EYECARE MEDICAL GROUP
PHASE 2 ADDITION AND RENOVATION
ADDENDUM NO. 3
JULY 23, 2013

This Addendum modifies, amends and supplements designated parts of the Contract Documents, Project Manual and Drawings for E.M.G. - Phase 2 - Addition and Renovation and is hereby made a part thereof by reference and shall be as binding as though inserted in its entirety in the locations specified herein. It shall be the responsibility of the Contractor to notify all Subcontractors and Suppliers he proposes to use for the various parts of the work of any changes or modifications contained in this Addendum.

SHEET
SKP-5

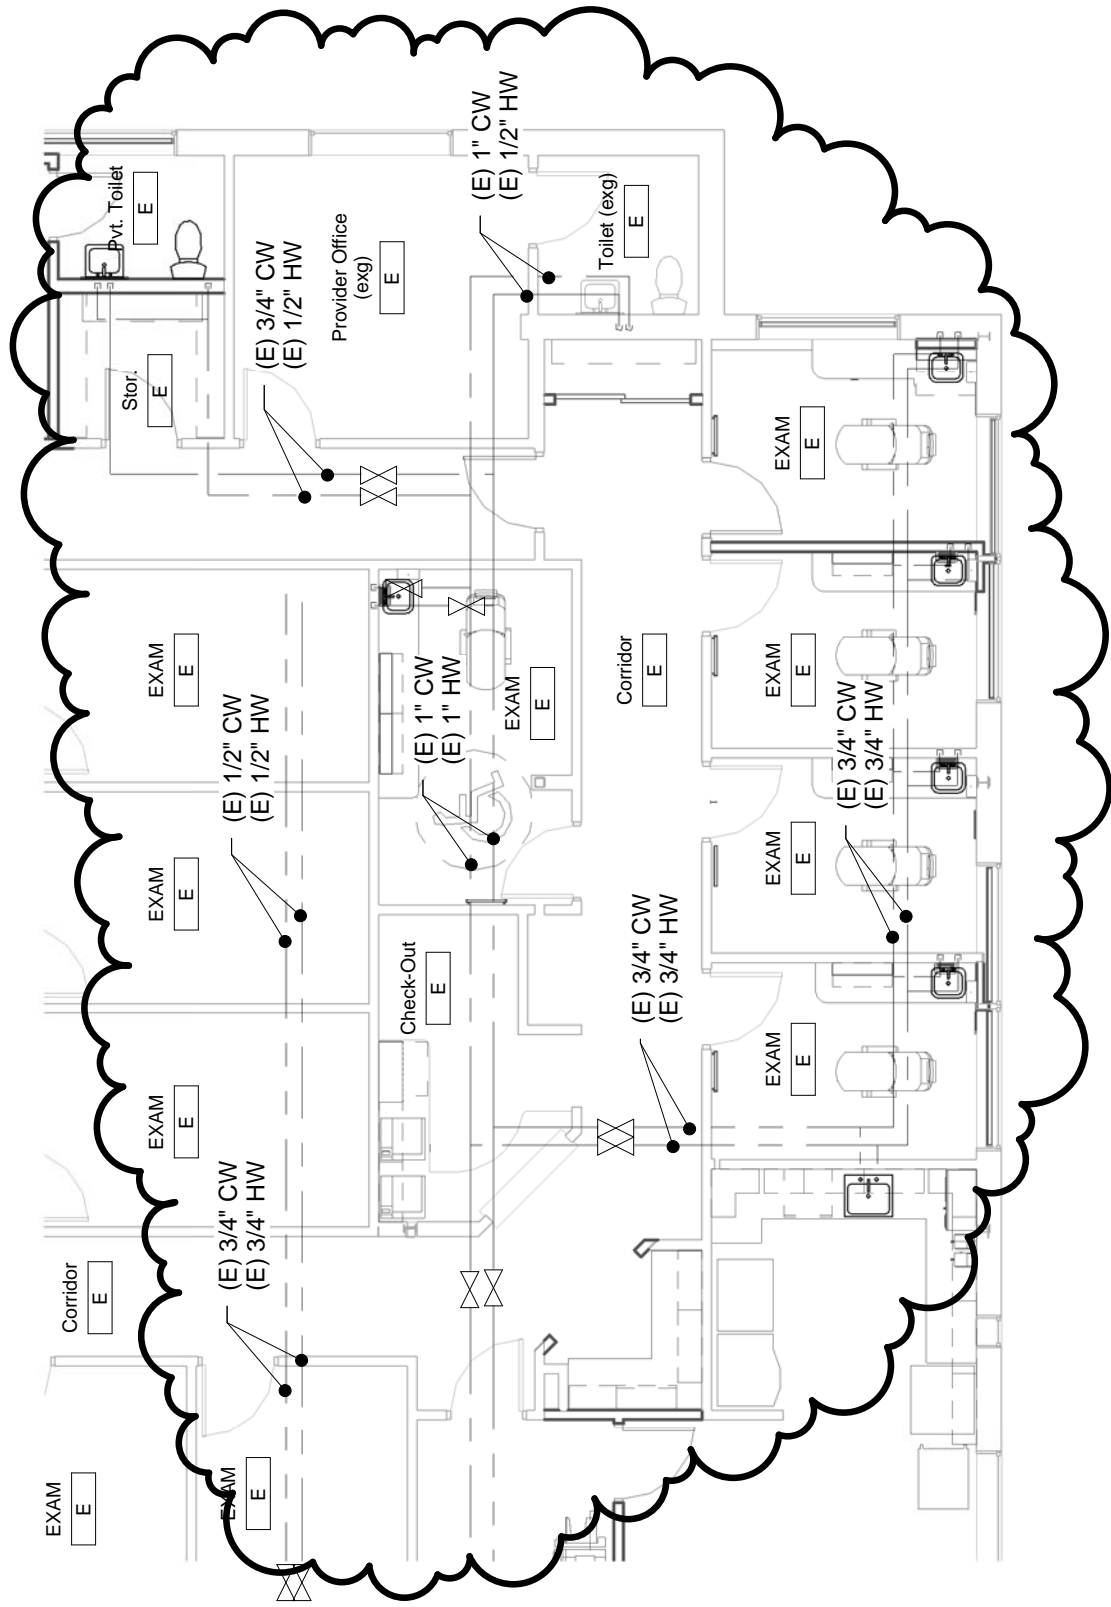
1. Sheet PL-400: **DELETE** reference to Boiler N^o5 as outlined in SKP-3, attached.
2. Sheet PL-100: Refer to SKP-5, attached for deleted key note N^o 3 and deleted note.
3. Sheet PL-102 Refer to SKP-6, attached for existing domestic piping completed under phase N^o1.
4. Sheet MH-101: Refer to SKM-1, attached for revisions to the Humidifier and Humidistat requirements for the OR's.
5. Sheet MH-400: **DELETE** the entire sheet. **ADD** in its place Sheet MH-400, with Revision N^o1, attached.
6. Sheet MH-600: **REVISE** the Pump schedule and **ADD** an Air Control Schedule as outlined on SKM-2, attached.

SHEET
SKE-01

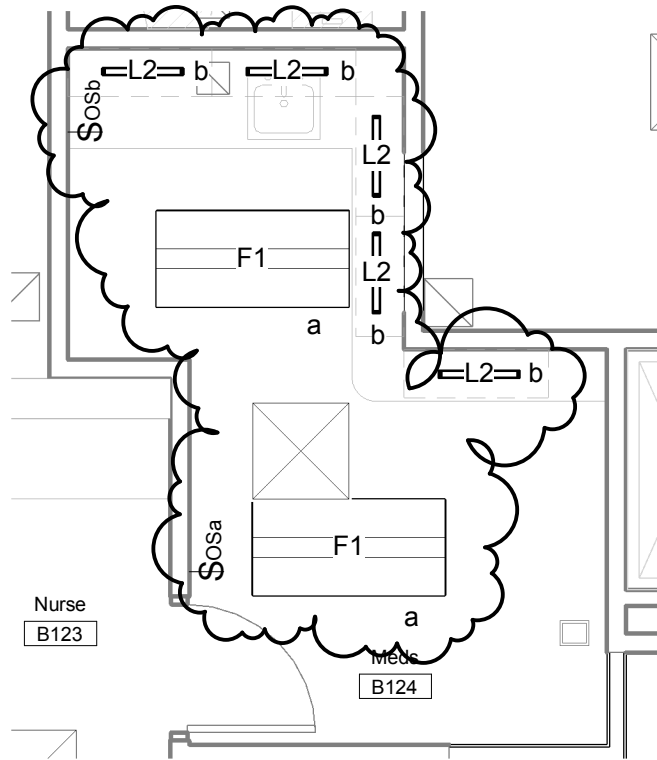
- 1.** Sheet EL-101: **REVISE** Med. Room B124 lighting layout as shown on SKE-01.
- 2.** Sheet EP-101: At Post Op B109, **DELETE** (6) wall mounted tel/data outlets mounted at 48".
Add in their place: (6) wall mounted telephone outlets mounted at 48".
- 3.** Sheet EP-500: **REVISE** Electrical Schedule of Mechanical Equipment as outlined in SKE-3, attached.
- 4.** Sheet EP-600: **REVISE** Panel Schedule – C1 as outlined in SKE-1, attached.
- 5.** Sheet EP-601: **REVISE** Panel Schedule – C2 as outlined in SKE-2, attached.
